Stone Brook Academy  
(previously known as Prestmore Academy)  
Site Selection Log

**SITE 1**  
01/06/2017

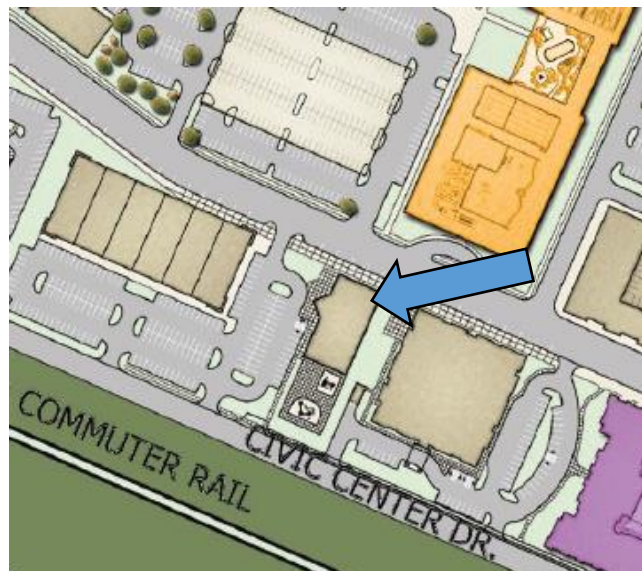
- ii. The second remnant lot is roughly 3-acres, located just west of the proposed Stone Brook Academy 1-acre lot, and is generally rectangular shaped.

Although this lot is smaller than the original larger 5-acre lot, this remnant 3-acre parcel is still of considerable size, and holds strong merit to be marketed/ developed. Sewer/ water stubs exist. Good access points exist. Location is good.

- Water/ sewer service have been pre-determined, ahead of development, for the larger 5-acre site. Stubs have been placed in the proposed Yolite row/ intersection, on Sunwood Drive; and stubs have been placed about midway within the remaining portion of the site.

- i. The location of these stubs would allow for services to be provided to the proposed Stone Brook site, and the two remnant lots. In summary, the pre-determined location of stubs is not a barrier to this proposed Stone Brook site location.

**E. WELL LOCATED ON LARGER PARCEL, Staff Development Review Comments**

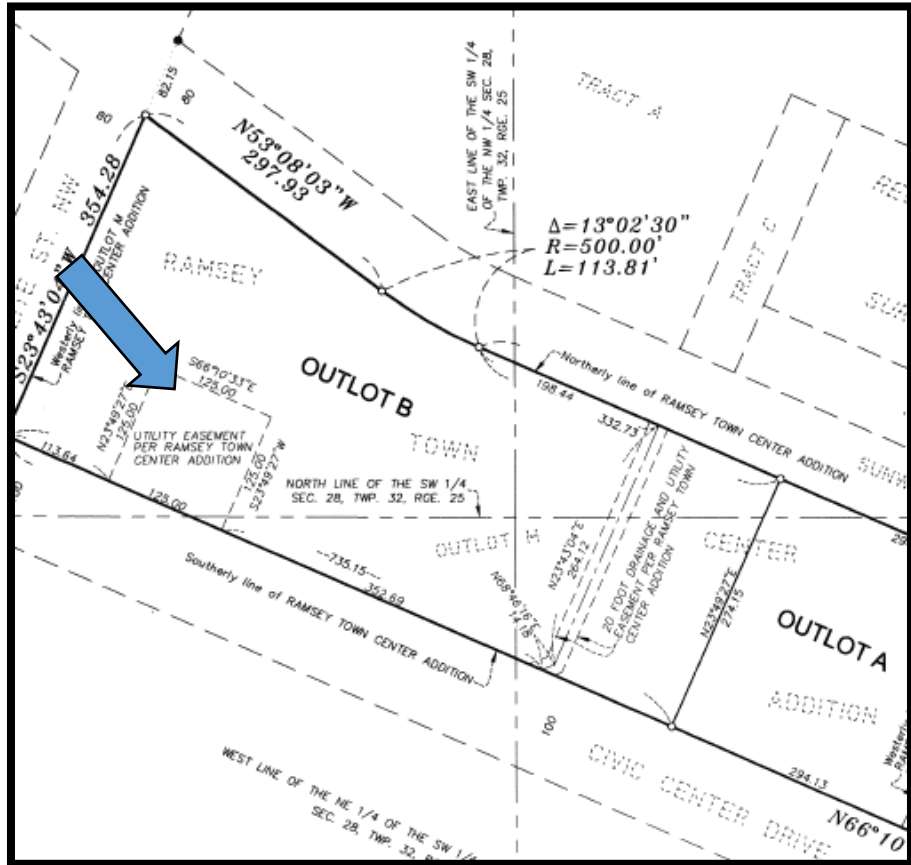
- There is a public well in the SW corner of the larger 5-acre site. This well includes a 125' easement. The well/ easement is *NOT* located on the proposed Stone Brook site. However, it will affect the 3-acre remnant lot (located west of the 1-acre Stone Brook lot). Generally speaking, when the 3-acre remnant site is developed, the well easement it will restrict potential building layouts. Buildings can't be constructed over the easement—however, parking and greenspace may be allowed. Staff wanted to simply note this item. This will be an issue to deal with, regardless of Stone Brook.

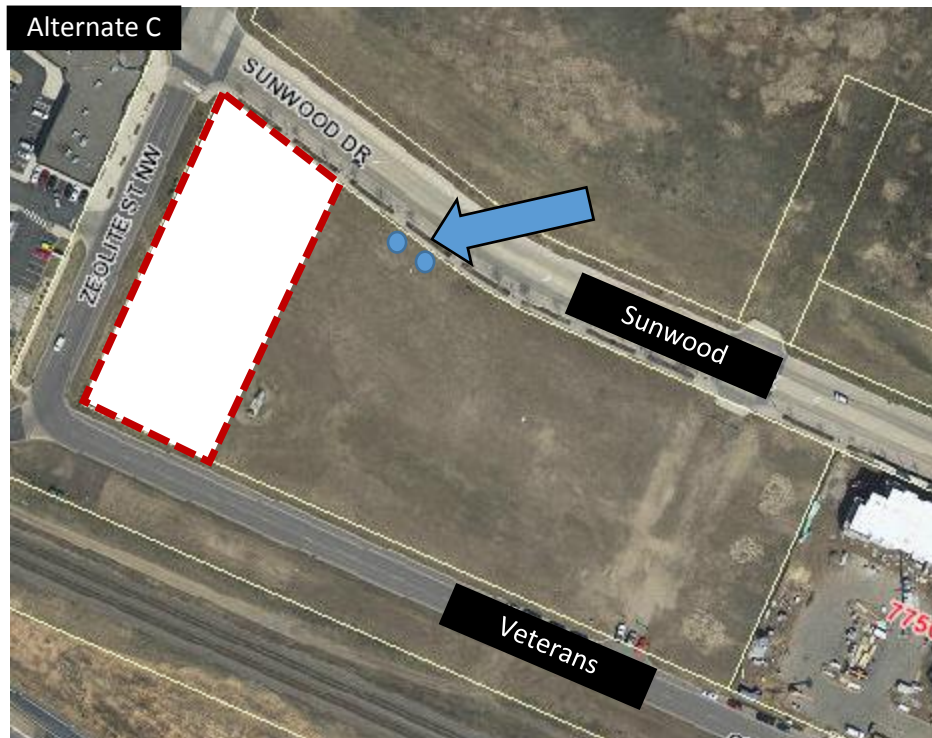
- Alternate A is physically too narrow, and too small to allow for what Stone Brook wants to accomplish (10,000 sf building plus a 1,500 sf playground). This was determined by their developer/ architect.
- Additionally, Stone Brook wants the focal point/ front of their building to be pressed up against Sunwood Drive (to be prominent). This layout would physically force the focal point of their building to be located central to the site (and the side of their building to be pressed against Sunwood). They feel this doesn't meet the "theme/vision" of The COR.
- Lastly, Stone Brook needs a round-about drop-off at their entrance—which requires a minimum 100' of site width (this remnant lot site is roughly 85' wide). Ideally, they want to have at least a 185' wide site.

- Alternate B rendered identical comments from Stone Brook (compared to Alternate A).
- Although they are able to pick up additional land to the south, the shape/ constraints of the lot still make it undesirable (as they want to front Sunwood with their building, on the north). The shape of this lot creates issues with their desired site layout.

- Alternate C works for Stone Brook. They understand the public well issue, and are willing to work around. This is not their #1 option—but would be willing to consider.

- Unfortunately, water/sewer stubs are located central to this site. Therefore, staff is concerned about how this user will access water/ sewer. One option is to punch into Sunwood Drive for new stubs (not recommended by staff). Another option is to run utilities internal to the property (also not recommended by staff).

- RE the water/ sewer stubs--the easy/ desired route would be to require this lot to be taken down all at once, or at least require the Stone Brook lot to extend all the way out to the utility stubs. In that scenario, Stone Brook would be picking up nearly 2x the land they need (which they would oppose—as would staff recommend against).

- Staff would also like to note, this user may “fit” better on the east side of this site (the 5-acre Outlot B). The western portion of this 5-acre site may be better suited for retail (as it’s located adjacent to retail). An academy/ daycare makes for a good transition (between residential/ retail).

- This option does have merit. If desired, staff would be happy to further investigate.
